May 11, 2009

Re: Request for Review
189 E. Lewelling Boulevard, San Lorenzo, California
ACEH Case RO# 184, RWQCB Case 01-1041

Subject: Fuel Leak Case No. RO0000013, New Performance, 186 E Lewelling Blvd., San Lorenzo, CA

White Line = 350'

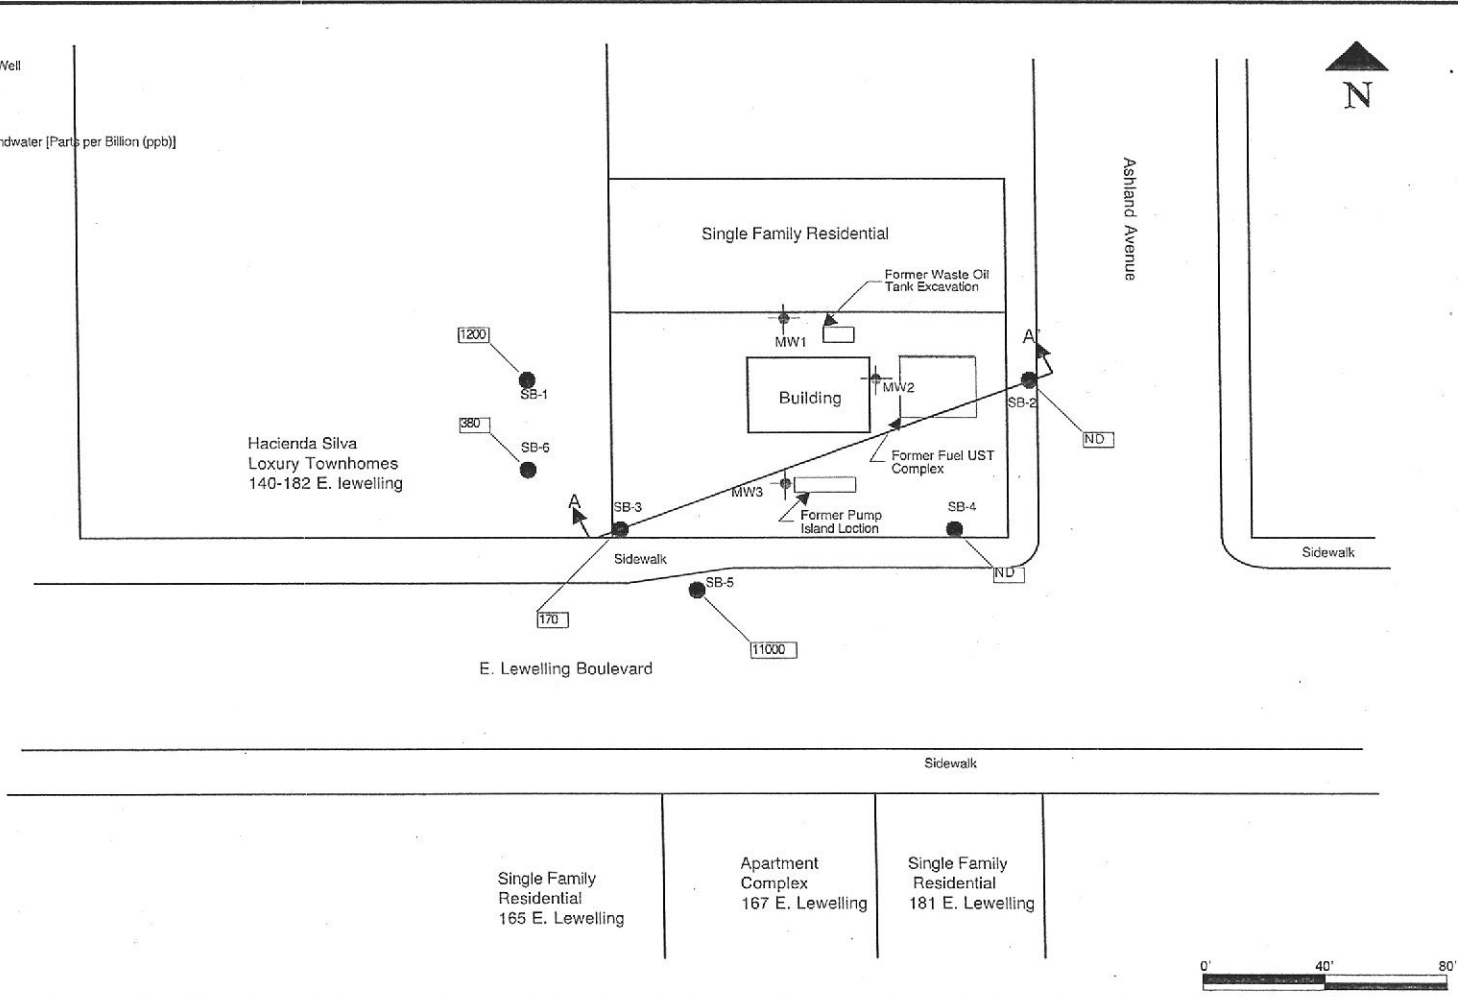
property; and 4) evaluation of San Lorenzo Creek as a potential sensitive receptor, even though San Lorenzo Creek is located over 350 feet south (cross-gradient of the Site) and is, in reality, a concrete lined flood control channel (see attached Google Earth figure, white line is 350 feet long).
